## **PLAN REVIEW SHEET**

2016-135

QuikTrip Corporation

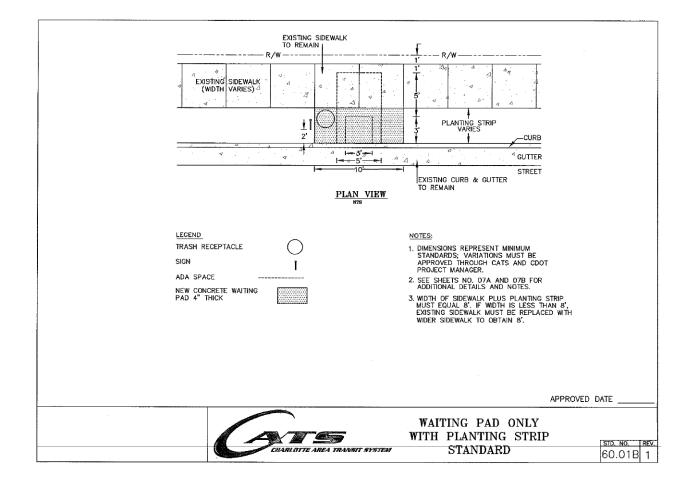
This site is located on an existing bus route. The Petitioner is requested to provide and construct a new waiting pad for a relocated bus stop on South Tryon Street. The recommended new location is where the proposed internal sidewalk connects to South Tryon Street before the right-turn lane into the development.

Below is an image of the standard detail (60.01B) for the requested bus stop pad. Permanent easement is requested, where dimensions exceed existing or proposed right-of-way limits.
